U.S. GEOLOGICAL SURVEY
RESEARCH REACTOR
LICENSE NO. R-113
DOCKET NO. 50-274

EMERGENCY PLAN
REVISION 15
OCTOBER 28, 2016

Enclosed is Revision 15 of the Emergency Plan for the U.S. Geological Survey TRIGA Reactor (GSTR) Facility (License R-113, Docket 50-274). The plan was revised without prior NRC approval per 10 CFR 50.54(q). The individual changes are detailed and discussed on the following page of this letter. All of the changed sections are marked with vertical lines in the margins of the Emergency Plan.

Figure 4 GSTR Facility Emergency Organization

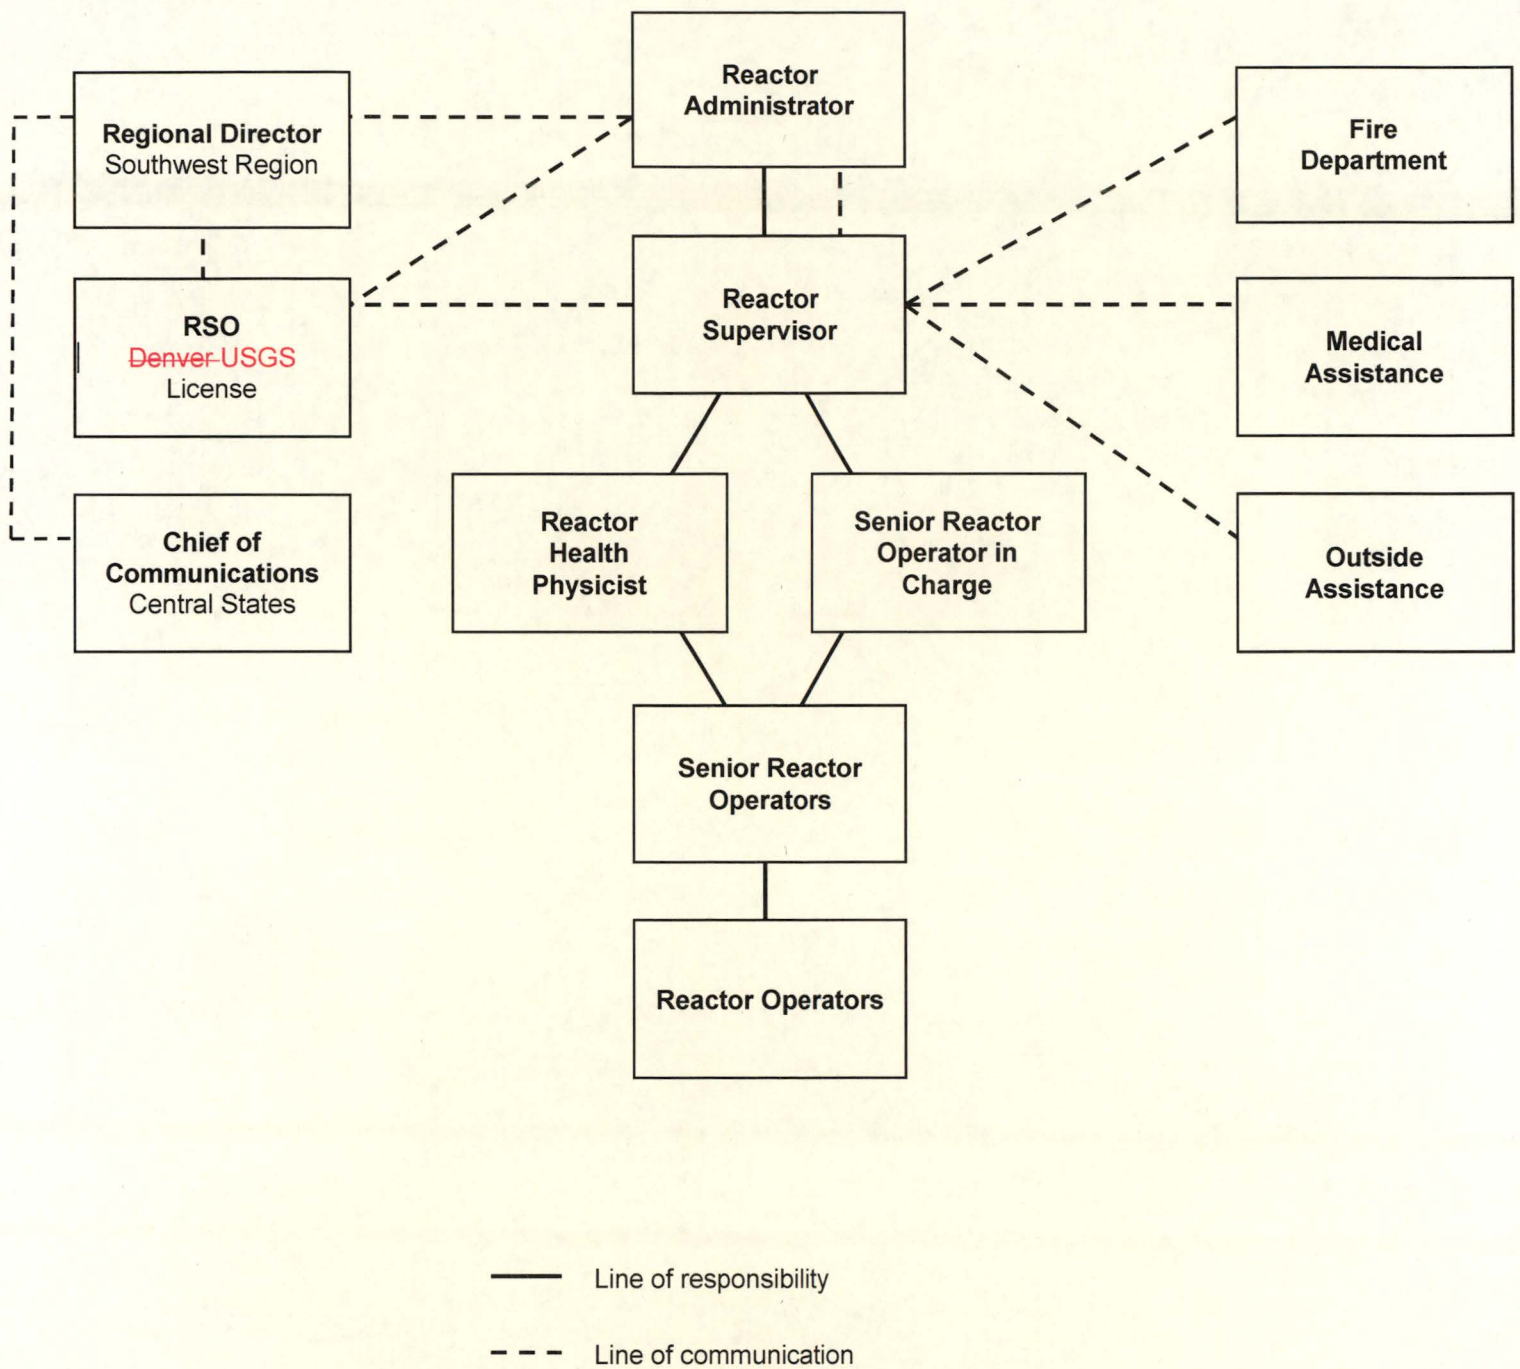
Page 6, within Figure 4. "RSO Denver License" was changed to read "RSO USGS License." There is now only one RSO for the entire USGS broadscope license.
